### **Meadowbank and Whale Tail MDRB Report No 31**

Report No 31  
Meadowbank Mine Dike Review Board (MDRB)  
Site visit August 16<sup>th</sup> to 18<sup>th</sup>, and Montreal meeting December 6<sup>th</sup> and 7<sup>th</sup>, 2023.

## **RESPONSE TO MEADOWBANK DIKE REVIEW BOARD – REPORT N° 31**

Photo #6 Sump on south wall of Whale Tail Pit.

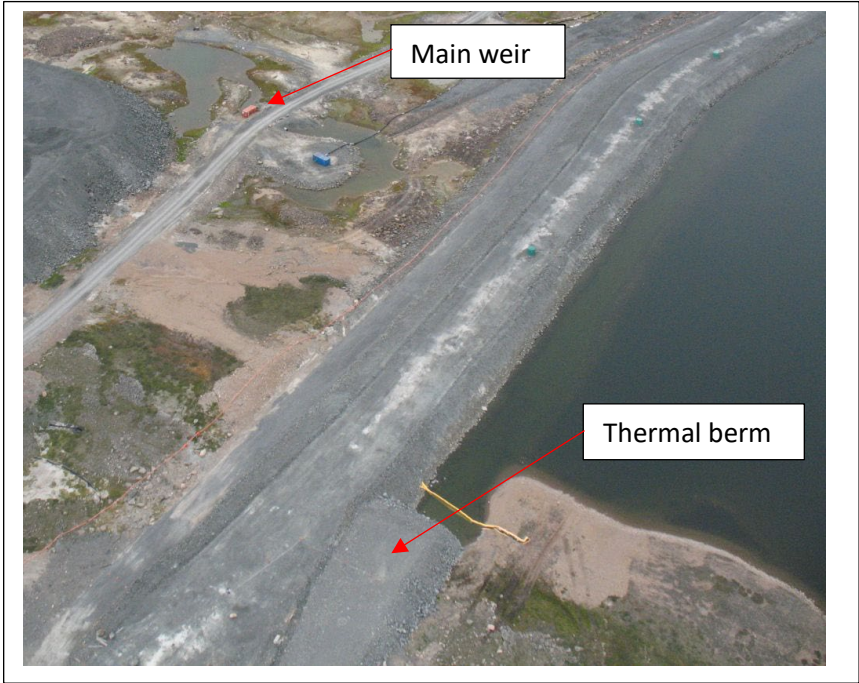
Improvements have been made to the Whale Tail Dike, an important component of water management at the site. Thermal berms have been added to the west and east abutments (Photos #7 and #8) on the lake side to encourage regeneration of frozen ground as this contributes to upstream slope stability and maintaining the seepage control measures of the Dike. Following poor drainage performance at the toe of the Dike during freshet 2023, the toe access road has been raised and reprofiled, the seepage collection trench has been remediated, and a SeaCan shelter has been added to the main weir for seepage monitoring. A piezometer installed in the culvert (Photo #9) enables continuous recording of flow rates for the collected seepage. However, given the significant run-off catchment area downstream of the dike, visual observation of conditions and rainfall/temperature measurements are required for interpretation of the measurements. Ice accumulation could also affect the piezometer readings but access to the weir is improved by the shelter. The current system provides a somewhat accurate means of documenting total seepage through the Dike (during low precipitation periods), however it is more suitable to identifying significant changes in the seepage rates that may be indicative of a problem with the Dike.

Photo #13 Saddle Dam SD1.

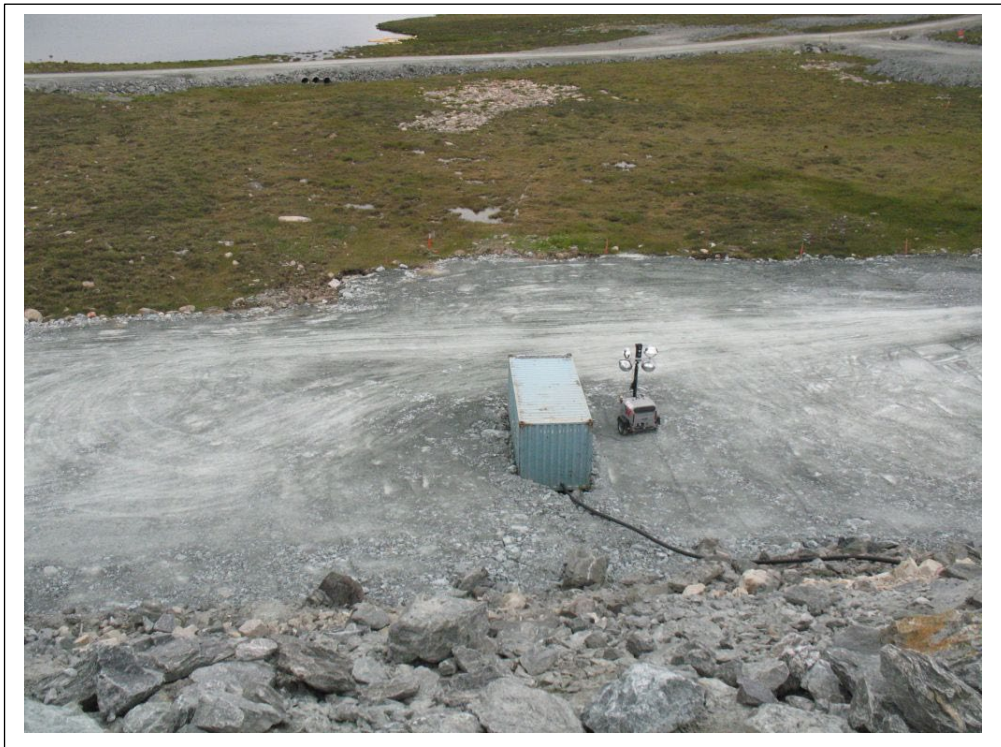
At SD1, the downstream toe area has been backfilled to reduce water accumulation from precipitation or snowmelt.
